# UNITED STATES DEPARTMENT OF THE INTERIOR RECEIVED BUREAU OF LAND MANAGEMENT

SUNDRY NOTICES AND REPORTS ON WELLEL 0 9 2013 Do not use this form for proposals to drill or to re-enter an

1. Type of Well		8. Well Name and No. NORTH INDIAN BASIN UNIT 21				
2. Name of Operator OXY USA WTP LP		9. API Well No. 30-015-28621				
3a. Address PO BOX 4294 HOUSTON, TX 77210	3b. Ph:	10. Field ar DAGGI	10. Field and Pool, or Exploratory DAGGER DRAW UPR.PENN SOUT

# North Indian Basin Unit 21 30-015-28621 OXY USA Inc. July 7, 2013 Conditions of Approval

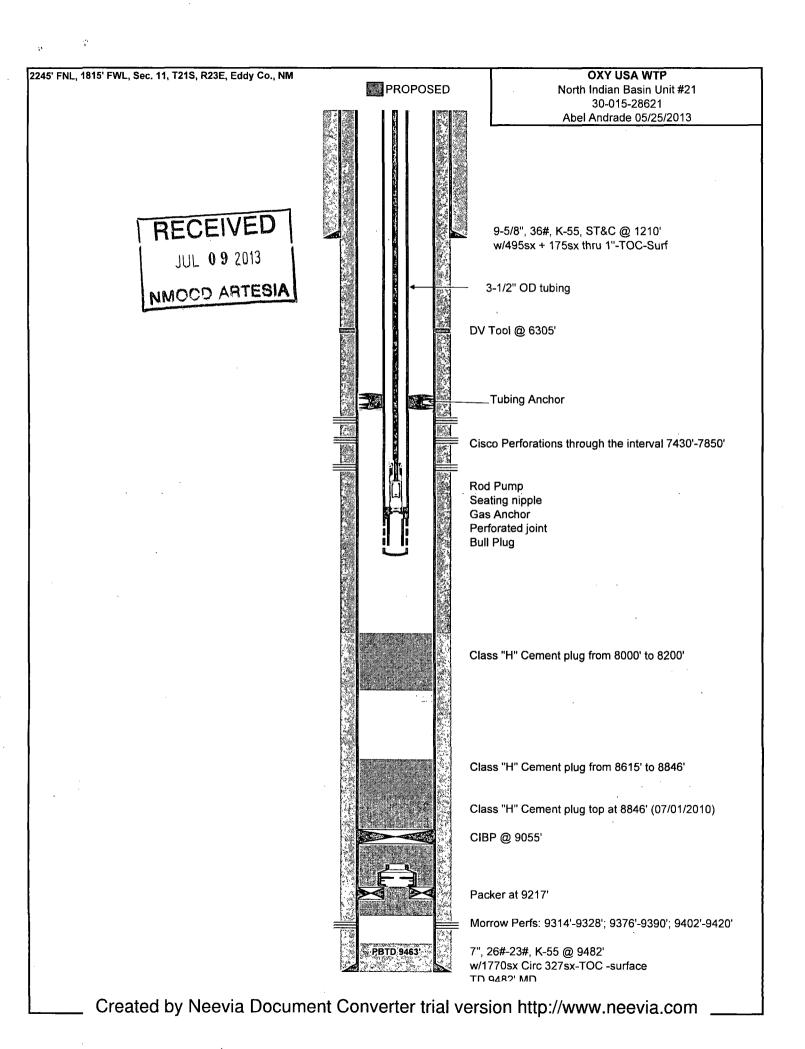
- 1. Operator shall Tag cement plug at 8,846'.
- 2. Cement procedure is approved as written.
- 3. Must conduct a casing integrity test to maximum treating pressure before any perforating or fracturing is done. Submit results to BLM. The CIT is to be performed on the production casing per Onshore Oil and Gas Order 2.III.B.1.h.

- 4. If CIT passes operator can recomplete as proposed.
- **5.** Before casing or a liner is added or replaced, prior BLM approval of the design is required. Use notice of intent Form 3160-5.

- 9. Operator to have H2S monitoring equipment on location.
- 10. A minimum of a 3000 (3M) BOP to be used. All blowout preventer (BOP) and related equipment (BOPE) shall comply with reasonable well control requirements. A two ram system with a blind ram and a pipe ram designed for the size of the work string shall be adequate. Tapered work strings will require an additional pipe ram. The manifold shall comply with Onshore Oil and Gas Order #2 Attachment I (3M Diagrams of Choke Manifold Equipment). The accumulator system shall have an immediately available power source to close the rams and retain 200 psi above pre-charge. The pre-charge test shall follow requirements in Onshore Order #2.
